MEMORANDUM

Subject: Briar Chapel WWTP Expansion
Application Review

At the request of the Briar Chapel Community Association (BCCA), Tetra Tech reviewed the "Request for Permit Minor Modification, Briar Chapel Wastewater Treatment Plant, Chatham County, WQ0028552", dated March 31, 2021, and prepared and submitted by John Phillips, PE, Diehl and Phillips, P.A., on behalf of Old North State Water Co., LLC.

Figure 1-1. Existing Versus Expansion Plan Layouts (Diehl and Phillips, 2021)

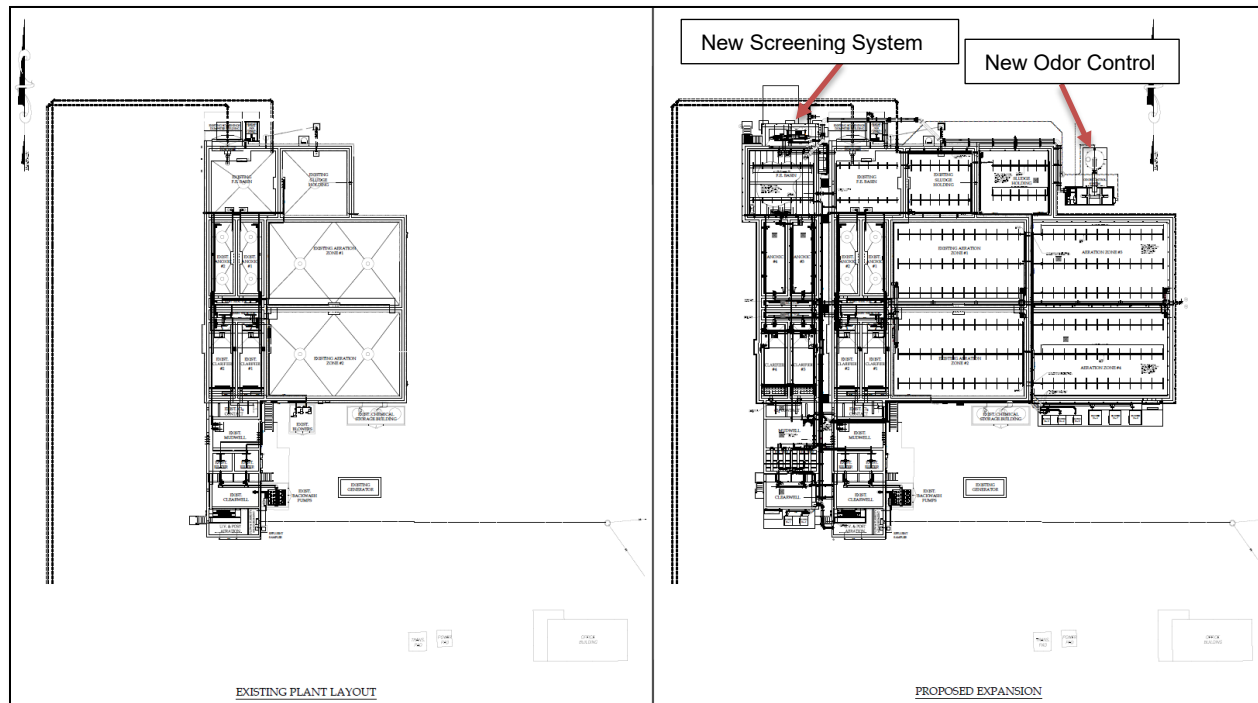
The proposed modifications include the following (Figure 1-1):

1. Installation of a new mechanical fine screen with screenings washing, compacting, and bagging features. This will replace the existing static screen.
2. Using submersible mixers in the two new anoxic zones for the WWTP expansion, rather than the 3 horsepower (hp) surface mounted mixers used in the two existing anoxic zones.
3. Retrofitting the existing surface aeration equipment in the flow equalization, sludge holding, and aeration basins with diffused aeration systems (fine bubble for the aeration basins, and coarse bubble for the flow equalization and sludge holding basins). Diffused aeration systems will also be used in the expansion basins.

4. Removing the permitted ultraviolet (UV) disinfection system and dechlorination system from the permit and relying exclusively on chlorination for disinfection.
5. Adding a two-stage (sulfate reduction biofilter followed by a carbon sorption filter for polishing) odor control system to treat gas from the covered flow equalization basins, and the new screening and dumpster.
